AFRRI TR83-1

**Safety analysis of modifications  
to upgrade the reactor ventilation  
system at Armed Forces  
Radiobiology Research Institute**

The following administrative changes are requested as amendment number 18 to the AFRRI reactor license R-84. These changes have been reviewed and do not represent an unreviewed safety question. The technical specifications changes requested reflect minor administrative and wording changes and are not changes in reactor safety systems. It is requested that these proposed changes become effective upon installation and testing of the modified reactor ventilation system.

Figure 2. Diagram of ventilation system. (This figure will replace Figure 3-5 in the Safety Analysis Report and Figure 4-1 in the Reactor Operations Manual.)

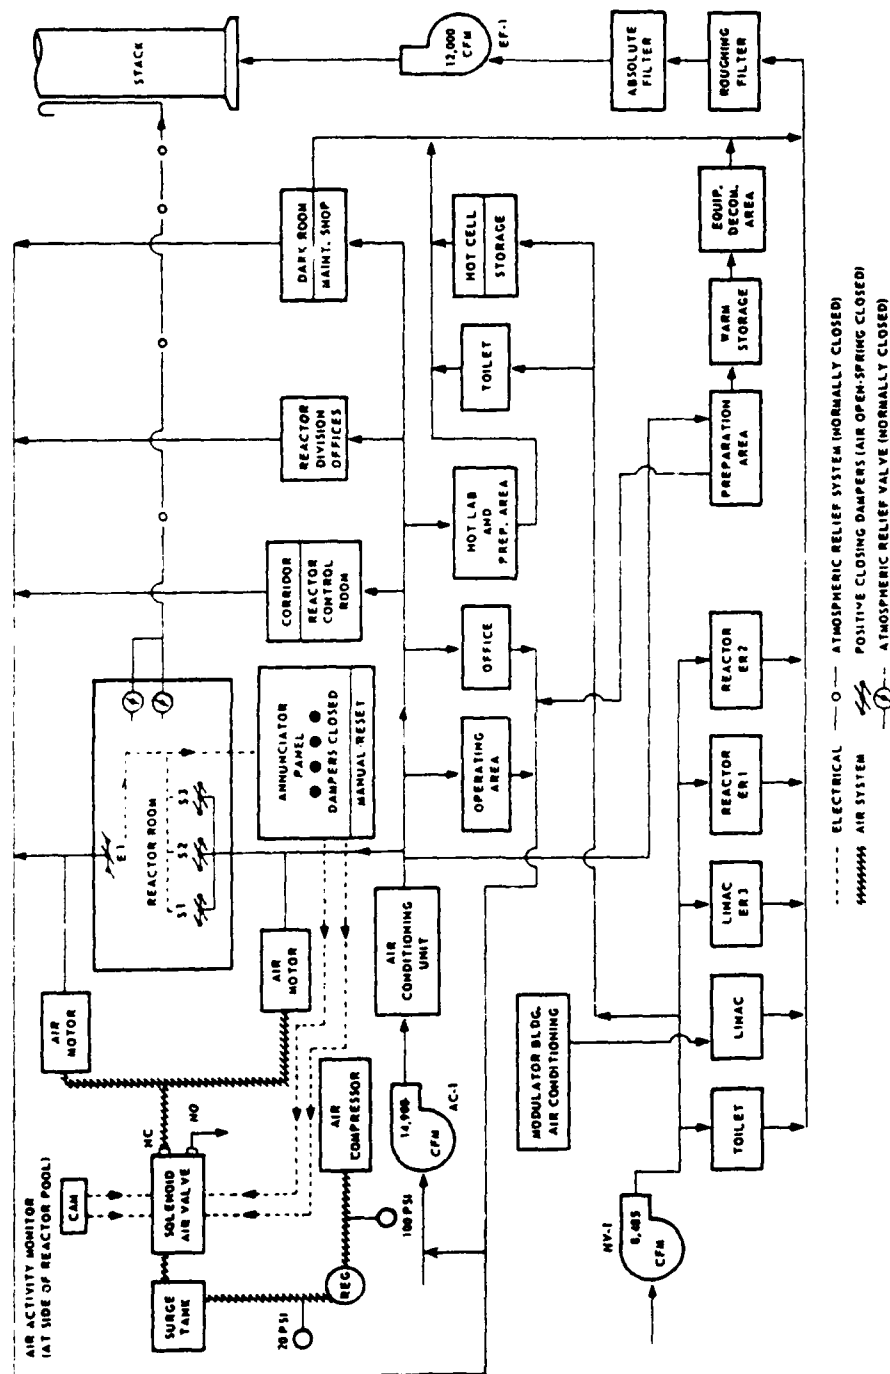
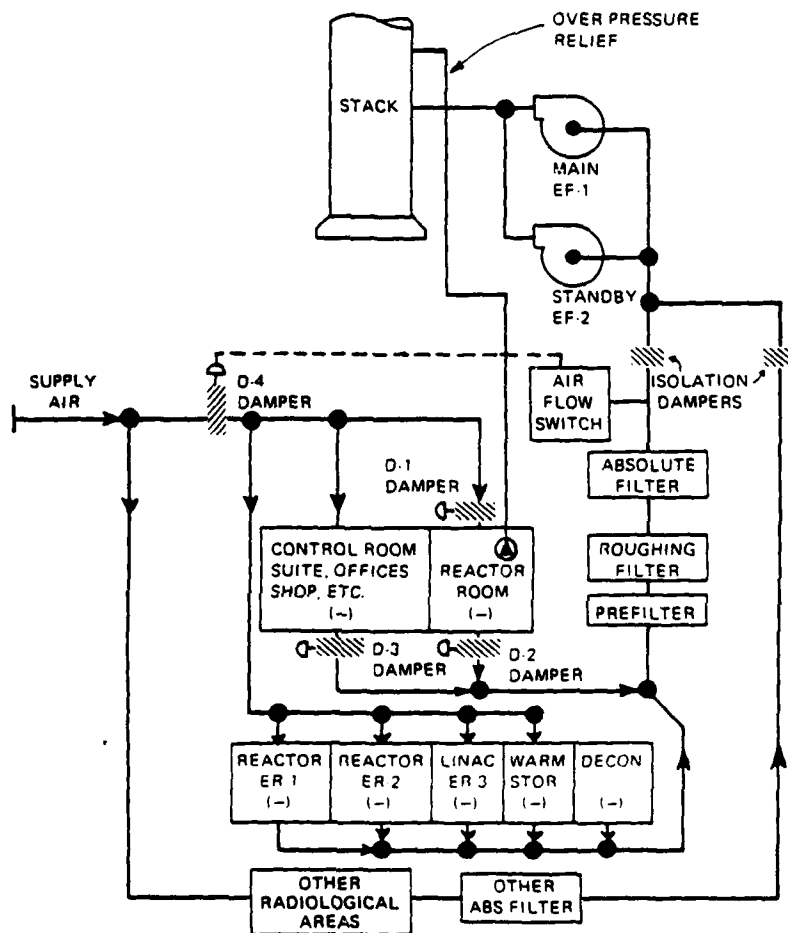
At present, AFRRI consists of five phases, or separate building units; each phase has its own ventilation system, which is independent of the reactor's ventilation system. Complications associated with the growth of the AFRRI complex require certain changes to be made in the AFRRI ventilation systems. It has been proposed that a centralized system designed to serve the entire AFRRI complex will replace the separate systems, which require constant adjustment and maintenance. The system servicing the reactor areas would become a separate branch of the AFRRI system; along with other branches having radiological significance, the reactor branch would receive special air treatment. Several improvements in the air system and in the manner in which it performs its intended functions would increase the safety relating to possible airborne radioactive contaminants from the reactor and reactor operations. The proposed air system is shown in Figure 2.

Replace figure 3-5 with inclosed figure 3-5A.

Change 4: Remove Figure 3-5; insert new Figure 3-5 (Enclosure 9).

Figure 3. Changes to Figure 3-5 in the Safety Analysis Report. Change 1: Single-pass air system for reactor area. Change 1A: Air supply for reactor area building.

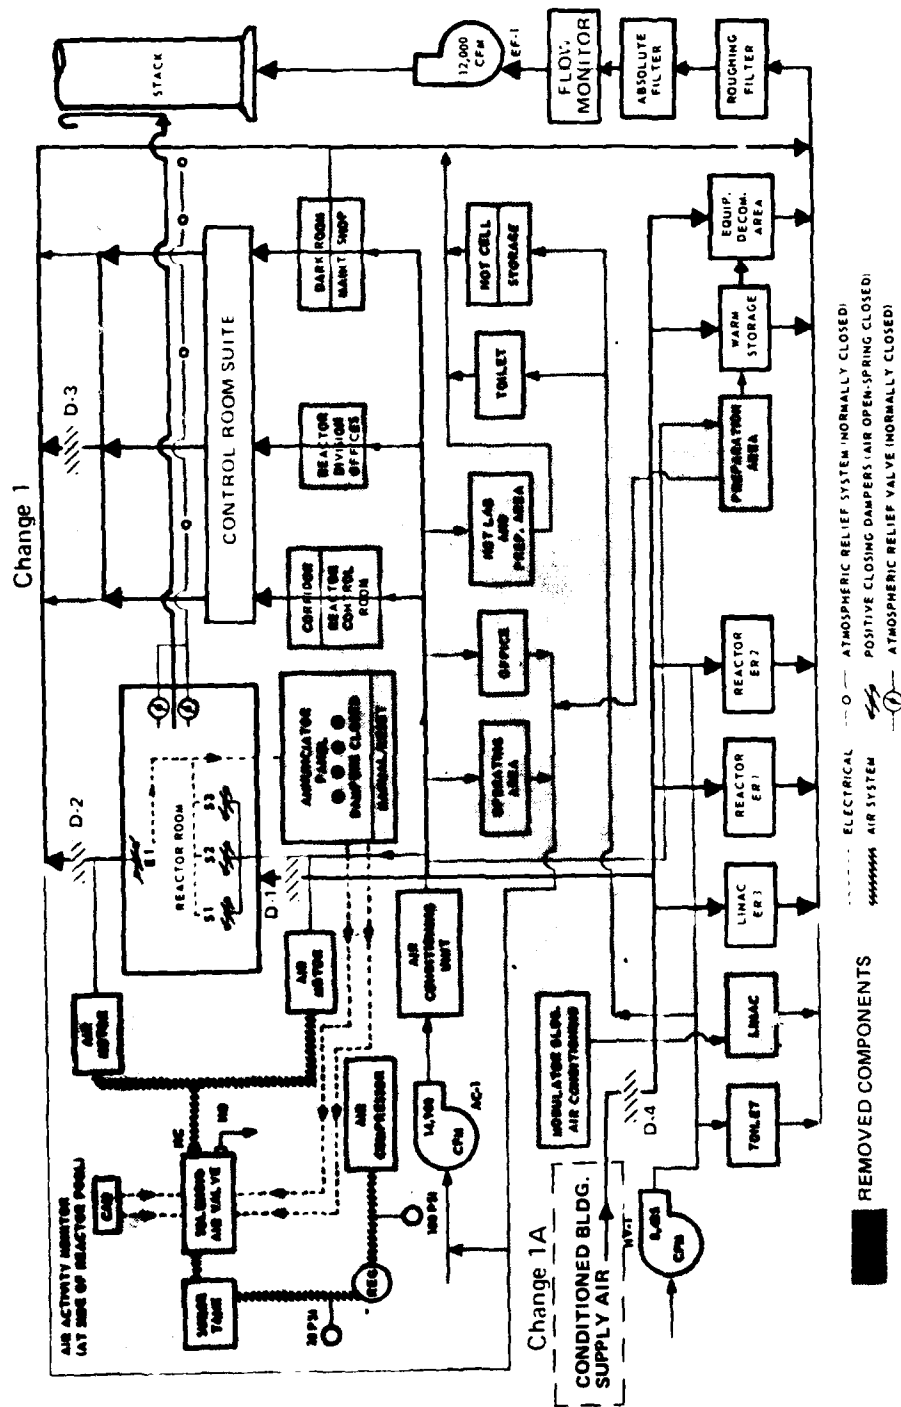
1. 100% Exhaust Air Versus Recirculation Air: The current air system uses recirculated air mixed with outside air in most of the reactor building, except in the exposure rooms (ER's), the restroom on the lower level, and the hot cell. These areas exhaust 100% of their air. The reactor room air ducts use dampers to provide isolation in case of an airborne problem. The upgraded system is more safe radiologically because all air in the reactor-related areas is 100% exhausted. In addition, the air in the reactor room is held at a negative pressure in relation to the control room suite, which is in turn held negative in relation to the rest of the AFRRI complex. This is shown as change 1 on Figure 3.

3. Supply Air: In the existing system, air is supplied to the reactor building from two air-handling units. A heating and ventilation unit supplies 100% outside air to the exposure rooms, the hot cell, and a restroom on the lower level. Air from these areas is exhausted thru the radiation stack. The other air-handling unit mixes outside air with recirculated building air, and supplies it to the rest of the reactor building. In the proposed system, the reactor branch will receive supply air that is filtered and conditioned to standard laboratory quality. See change 1A on Figure 3.

Figure 4. Change 2 to Figure 3-5 in the Safety Analysis Report: Reactor building areas removed from system

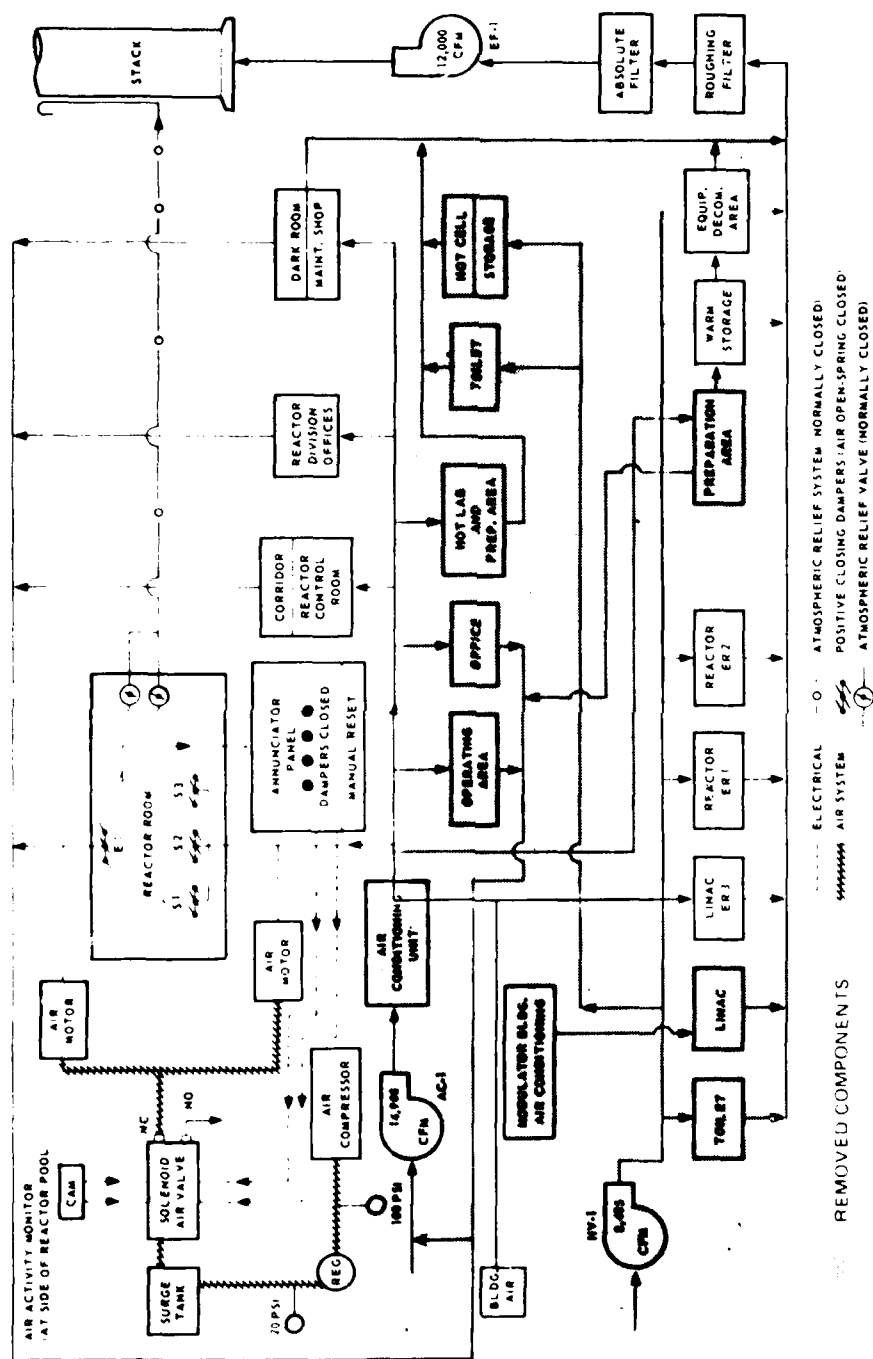
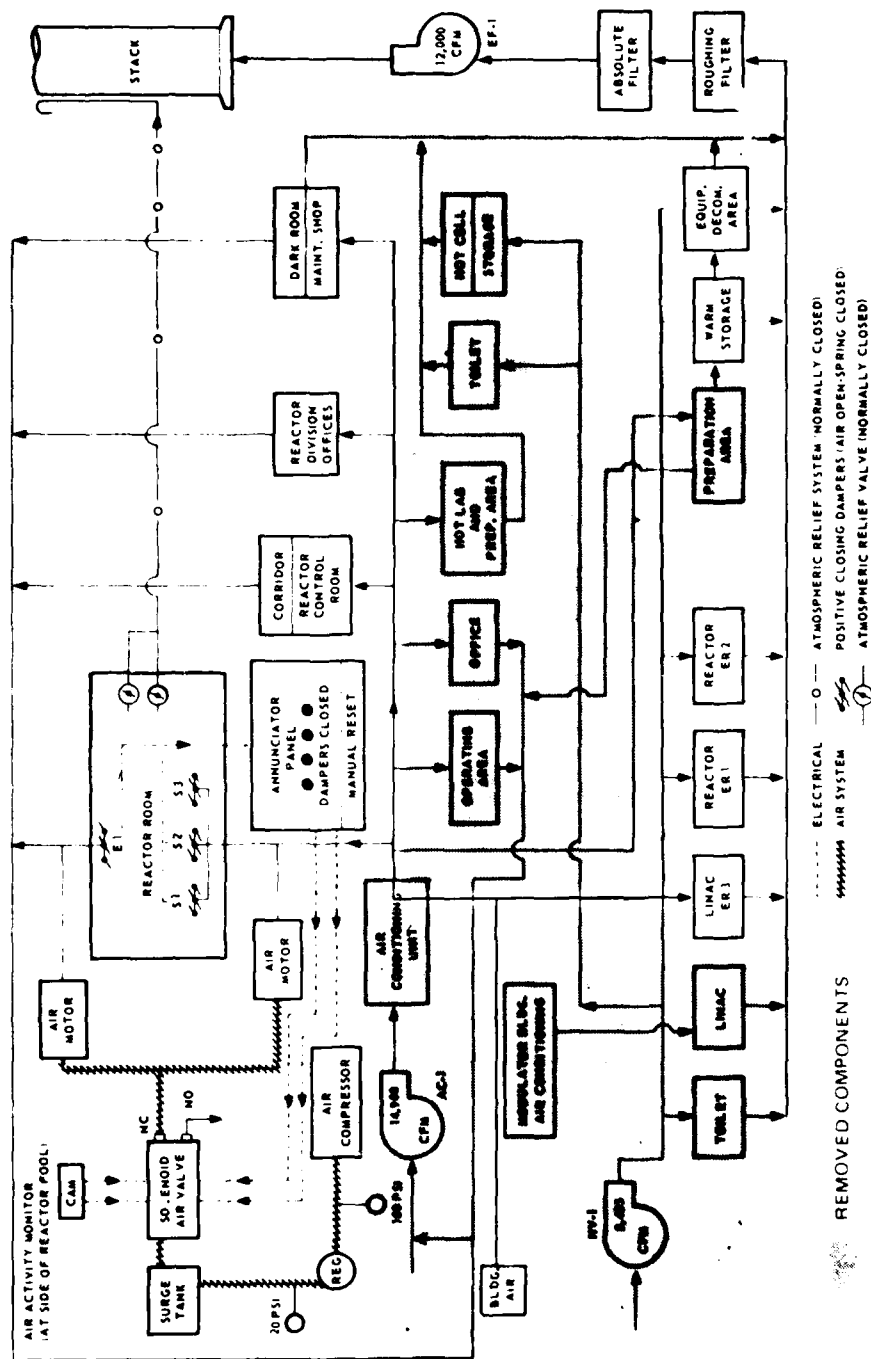
2. Areas Excluded From the System: When the current system was installed, certain areas were included in the reactor air system because they were located in the reactor building. However, these areas are not of direct concern to the reactor-related operations, and have been excluded from our realm of consideration. Areas having radiological significance not related to the reactor are considered as other branches having special radiological treatment. The changes are shown in Figure 4.
